**Bridge Factors Factual Report Attachment 21 – BPA Cracks Report No. 1 - Email from
Mr. Jose Morales of BPA to Mr. Rodrigo Isaza of MCM dated February 13, 2018**

From: Jose Morales
Sent: Tuesday, February 13, 2018 9:50 AM
To: Rodrigo Isaza [REDACTED]
Cc: [REDACTED] Ernie Hernandez [REDACTED] Pedro Cortes; Rafael Urdaneta; [REDACTED] Carlos Chapman; Maria Christina Acosta
Subject: Main Span 1 - Cracks Inspection on Truss Members
Attachments: FIU PEDESTRIAN BRIDGE CRACK INSPECTION.pdf

**FIU Pedestrian Bridge / BT-904
Crack Inspection Report**

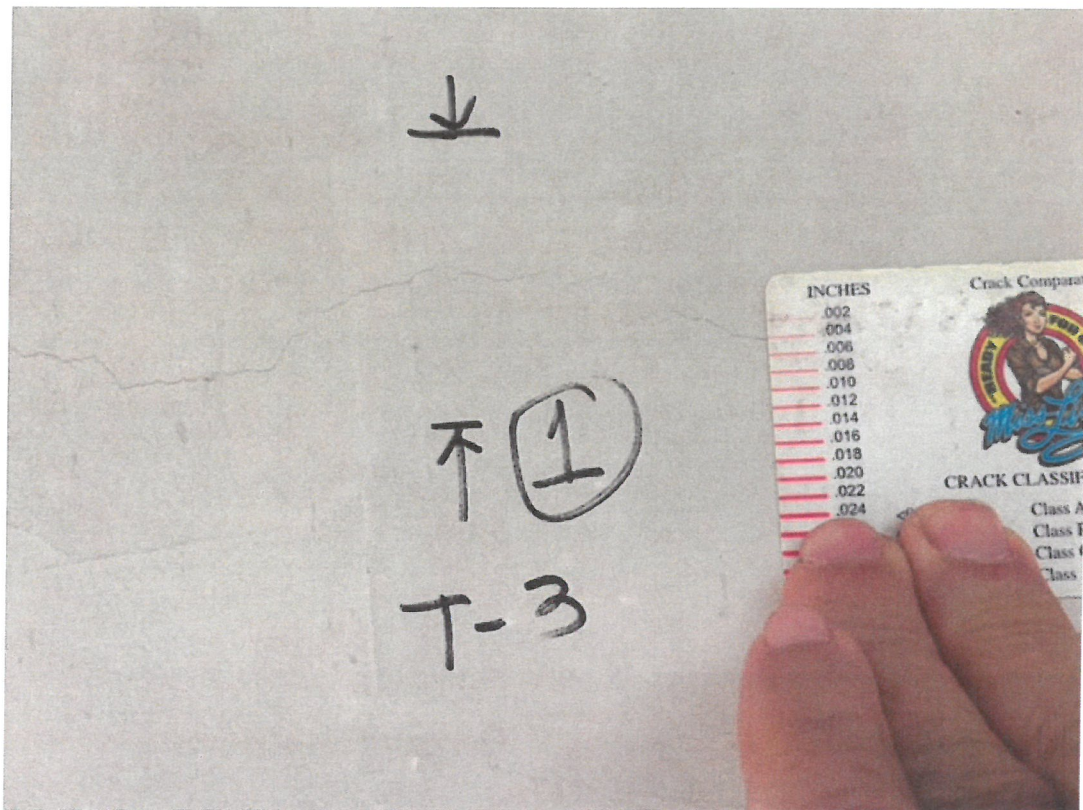
Bolton Perez & Associates, serving as the CEI for the project performed a visual inspection of main span truss members on 02-06-18 after PT bars tendons No 2 and No 11 were stressed. Cracks were found at moment of the inspection. These have been identified per truss member and a consecutive number within the member. The intent is to monitor these cracks after the bridge is fully tensioned and the main span is at the final location.

The members showing these small cracks are truss members that share the same blister at the canopy of the already stressed members No 2 (stressed 1/30/18) & No 11 (stressed 1/29/18) . We believe, this first stressing operation has temporarily created tension on members No 3 & No 10; thus, creating cross sectional cracks transferring the tension loads to the steel on these members. No other truss members within span 1 show any cracks similar to these shown on members No 3 & No 10.

- CEI's observations of the conditions of members 3 and 10 after stressing members 2 and 11 are temporary in nature. The current condition will change as soon as the stressing of the PT bars in members 3 and 10 is performed.
- The release of the canopy falsework will improve the state of stress in members 3 and 10.
- As mentioned in CEI's Report, the observations regarding the current condition of members 3 and 10 are the results of an intermediate step in the stressing operation.
- It is recommended that the truss members not be marked with a marker/sharpie as this will lead to discoloration of the concrete.

1. Crack T3-1

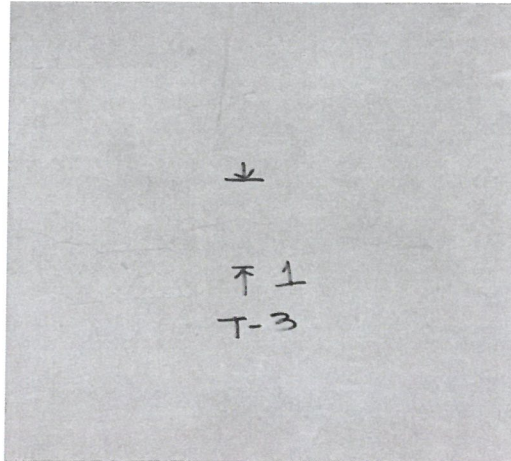
Location: Truss member No.3, approximately 70 inches measured from the bottom of the member, extended around the cross section.

Classification: Crack type A (<0.007 inches).

Measured: 0.04 inches.

2. Crack T3-2

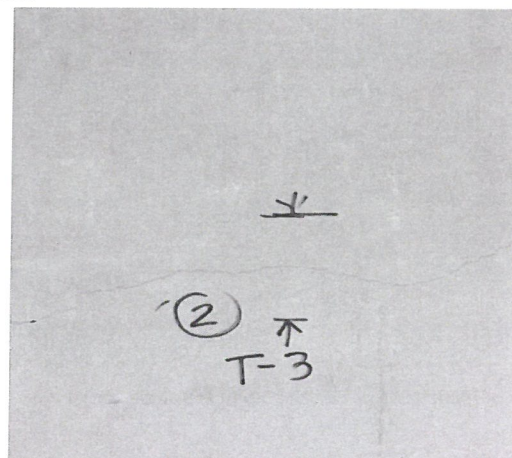
Location: Truss member No.3, approximately 77 inches measured from the bottom of the member, extended around the cross section.

Classification: Crack type A (<0.007 inches).

Measured: 0.04/006 inches.

3. Crack T10-1

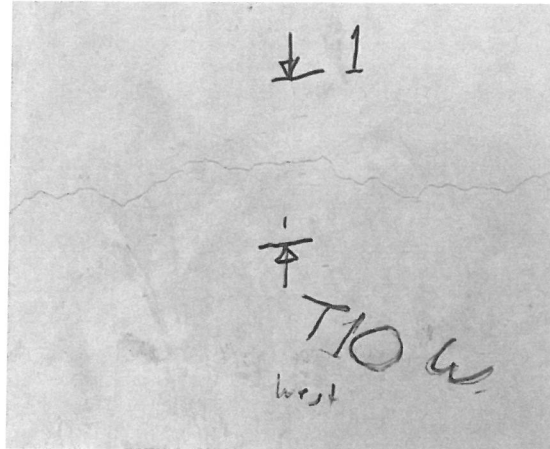
Location: Truss member No.10, approximately 119 inches measured from the bottom of the member, extended around the cross section.

Classification: Crack type A (<0.007 inches).

Measured: 0.04 inches.

4. Crack T10-2

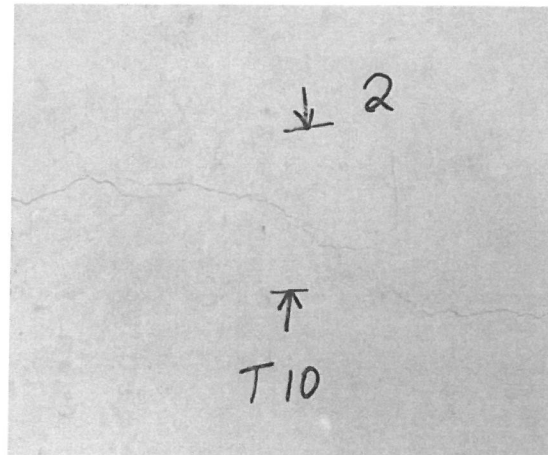
Location: Truss member No.10, approximately 126 inches measured from the bottom of the member, extended around the cross section.

Classification: Crack type A (<0.007 inches).

Measured: 0.04 inches.

5. Crack T10-3

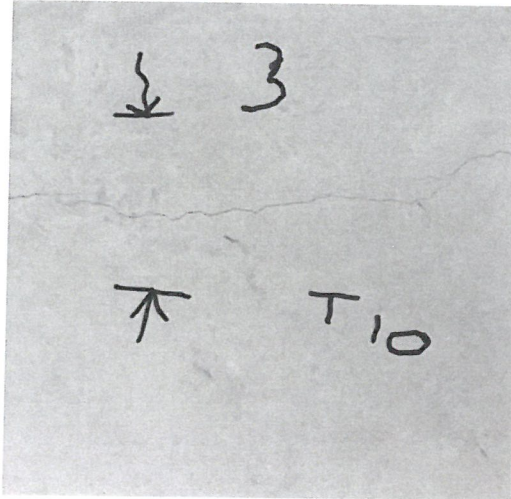
Location: Truss member No.10, approximately 150 inches measured from the bottom of the member, extended around the cross section.

Classification: Crack type A (<0.007 inches).

Measured: 0.04 inches.

6. Crack T10-4

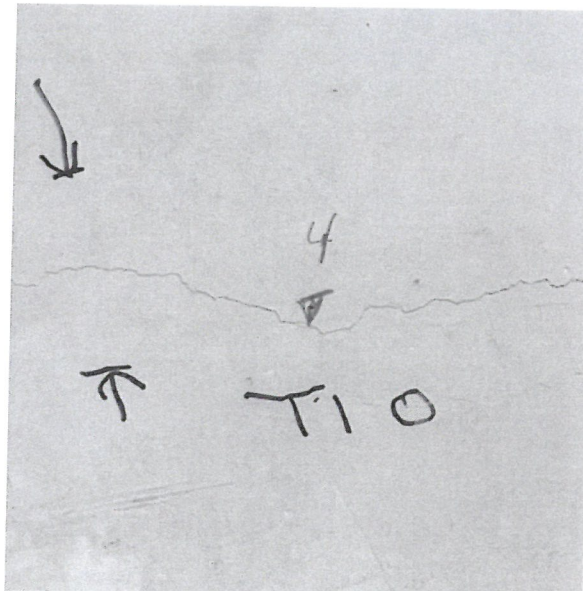
Location: Truss member No.10, approximately 168 inches measured from the bottom of the member, extended around the cross section.

Classification: Crack type A (<0.007 inches).

Measured: 0.04 inches.
